Overview of Plan Change Request for the Use of Replacement Panels 11 and 12

Karen Day, Project Manager
EPA Compliance
Los Alamos Technical Associates

December 7, 2023

Waste Disposal Panel Design and TRU Waste Volume Capacity Limit

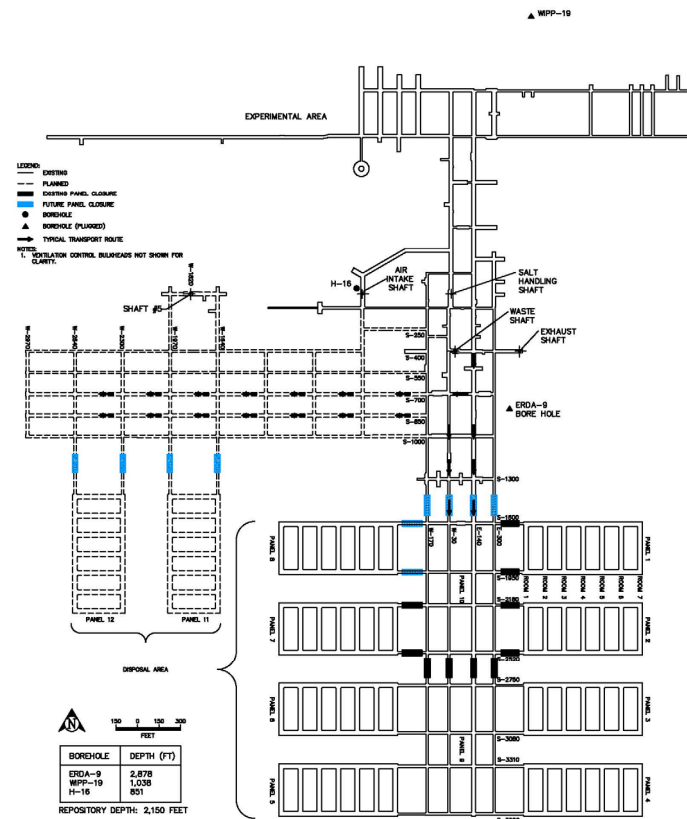
- The original design of the WIPP repository consists of ten panel-equivalents.
- Panels 1 through 8 consist of seven waste disposal rooms, each with an intake and exhaust drift.
- Equivalent Panels 9 and 10 are made up of a portion of the main access drifts and cross-cut drifts, located between Panels 1 through 8.
- The WIPP Land Withdrawal Act established the total TRU waste disposal volume capacity limit of the WIPP facility as 6.2 million ft³.
- The RPPCR does not impact the TRU waste disposal volume capacity limit.
